## QUALITY ASSURANCE -- NON-CONFORMANCE REPORT

**Report No:** NCR-000525

**Reference Description:** Base Metal damage in SPCM material during the weld repair process in Lift 12 Floorbeam

**Job Name:** SAS Superstructure

FB3006-001-148 (Web to flange)

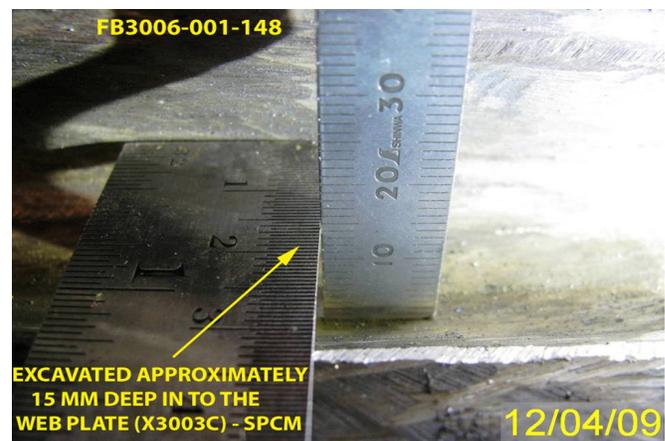
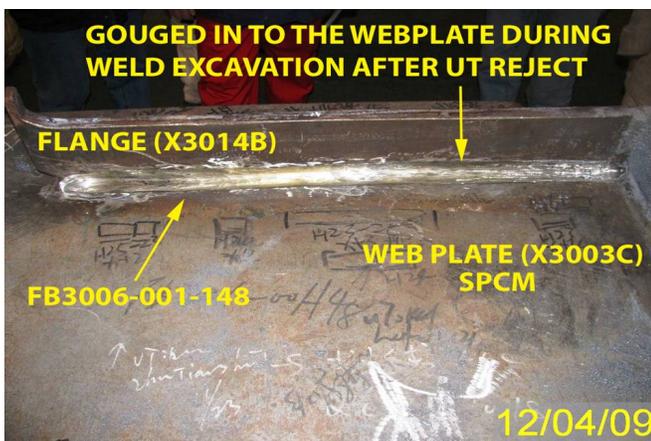
During random in process visual inspection at Bay #2, the Quality Assurance Inspector (QA) observed an OBG FL3 lift 12 Floor Beam web plate-X3003C had been arc-gouged approximately 15 mm in depth into the base material and 670 mm in length during the excavation of complete joint penetration (CJP) web to flange T-weld joint. The excavation was supposed to be for the weld reject that was found by ZPMC Ultrasonic Testing (UT) technician.

Special Provisions Section 8.3: "Quality Control (QC) shall be the responsibility of the Contractor. As a minimum, the Contractor shall perform inspection and testing of each weld joint prior to welding, during welding, and after welding as specified in this section and to ensure that materials and workmanship conform to the requirements of the contract documents."

AWS D1.5 2002, Section 3.7.1; "The removal of the weld metal or portions of the base metal may be done by machining, carbon arc cutting and gouging, thermal cutting, chipping, or grinding. It shall be done in such a manner that the remaining weld metal or base metal is not nicked or undercut."

"Unacceptable portions of the weld shall be removed without substantial removal of the base metal."

**Reference Resolution:** ZPMC recognized that this plate was SPCM material and issued a CWR. Please see the attached documents which shows an approved CWR.

The documentation received is sufficient to close this NCR.

FB3006-001-148 (Web to flange)

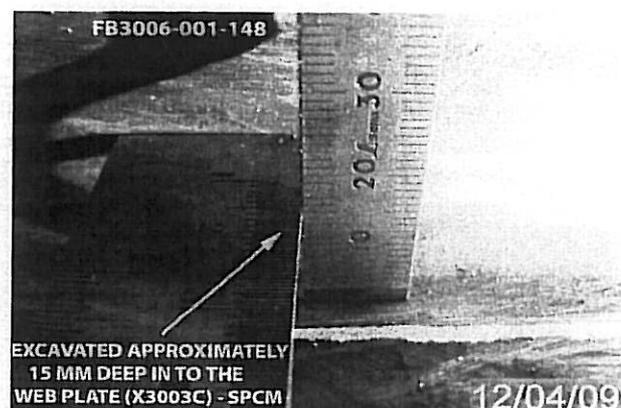
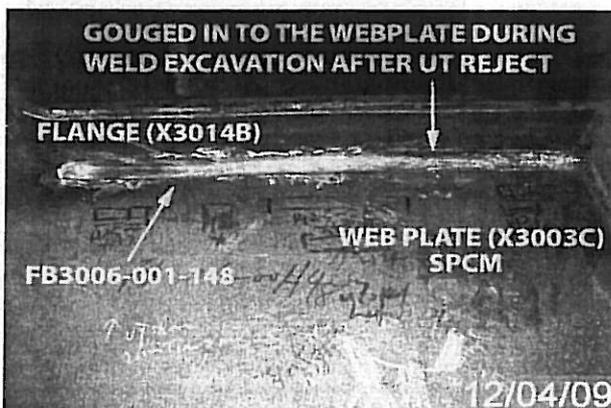
During random in process visual inspection at Bay #2, the Quality Assurance Inspector (QA) observed an OBG FL3 lift 12 Floor Beam web plate-X3003C had been arc-gouged approximately 15 mm in depth into the base material and 670 mm in length during the excavation of complete joint penetration (CJP) web to flange T-weld joint. The excavation was supposed to be for the weld reject that was found by ZPMC Ultrasonic Testing (UT) technician.

Special Provisions Section 8.3: "Quality Control (QC) shall be the responsibility of the Contractor. As a minimum, the Contractor shall perform inspection and testing of each weld joint prior to welding, during welding, and after welding as specified in this section and to ensure that materials and workmanship conform to the requirements of the contract documents."

AWS D1.5 2002, Section 3.7.1; "The removal of the weld metal or portions of the base metal may be done by machining, carbon arc cutting and gouging, thermal cutting, chipping, or grinding. It shall be done in such a manner that the remaining weld metal or base metal is not nicked or undercut."

"Unacceptable portions of the weld shall be removed without substantial removal of the base metal."

Submit CWR for Engineer's review, repair said damage in accordance with approved CWR, and perform NDT required to verify weld quality.

Contractor has submitted CWR along with subsequent NDT report verifying the weld is now in conformance with Contract specifications.

(UT探伤返修第二次, 并且该板为SPCM板) FB3006-001-148

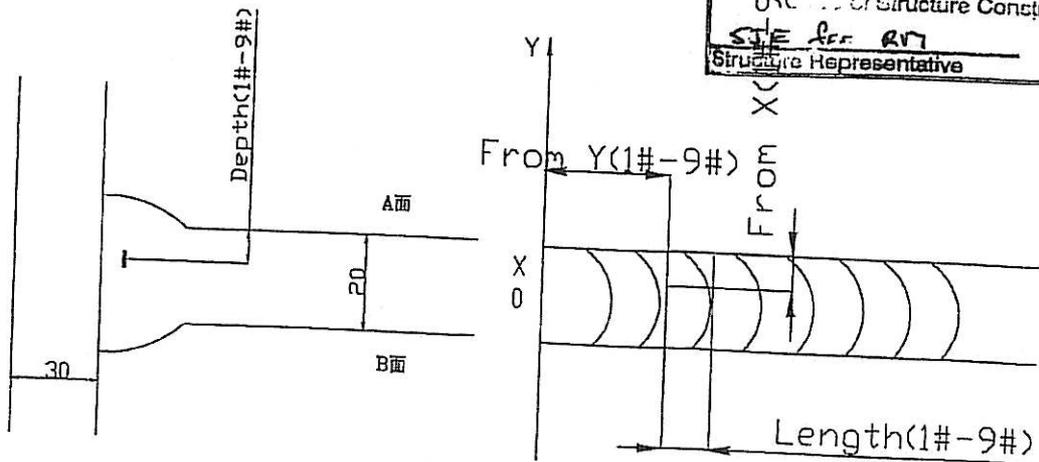
Preheat to 65°C prior to grinding or gouging.

Rejectable indications were found by ultrasonic inspection for a second repair on the SPCM plate.

1. The weld defect location may not have been properly identified prior to grinding, i.e. the X and Y location was incorrect or the excavation was not centered on the defect, therefore the excavation did not encompass the whole defect.

1. QC and a Lead CWI shall be present and direct all gouging, grinding and welding operations during this repair.
2. QC and a Lead CWI shall have a copy of the CWR in hand and shall be at the repair location prior to the repair.

3. QC and the Lead CWI shall direct the repair to ensure the repair is per the disposition requirements.
4. Clean excavation area of all loose debris including UT powder, and preheat according to the Table 1 of the New Repair Procedure prior to gouging. ~~No preheating is required if grinding is only being used.~~ PREHEAT TO 650

5. Gouge and/or grind accurately from nearer side from metal edge ( $D \leq 0.65T$ , "D" is depth of defects, "T" is thickness of metal) to remove all defects. PREHEAT TO 650

6. Prepare a right joint according to approved WPS.
7. Grind repair area smooth to a shiny finish with tapered ends to ensure staggered stops and starts, and perform VT and MT to ensure the defects have been removed.

8. Clean the excavation area of all loose debris including MT powder and UT gel.
9. QC and a Lead CWI shall verify and document all defects have been removed prior to repair welding.

10. Preheat and weld according to the Table 1 of the New Repair Procedure.
11. QC and a CWI shall enforce interpass cleaning by performing a visual inspection prior to the disposal of each pass.

12. Perform post weld heating according to the Table 1 of the New Repair Procedure.
13. Allow the weld to cool to ambient temperature gradually. Grind the repaired area flush with base metal or the adjacent weld after post weld heating.

14. Wait 48 hours after the repair area has cooled to ambient temperature before performing NDT.
15. Check the weld by performing VT, MT and UT to the repair area according to the drawings. Additional NDT in accordance with the applicable notes in Special Provisions Section 10-1.59 'Steel Structure', subsection 'Inspection and Testing'.
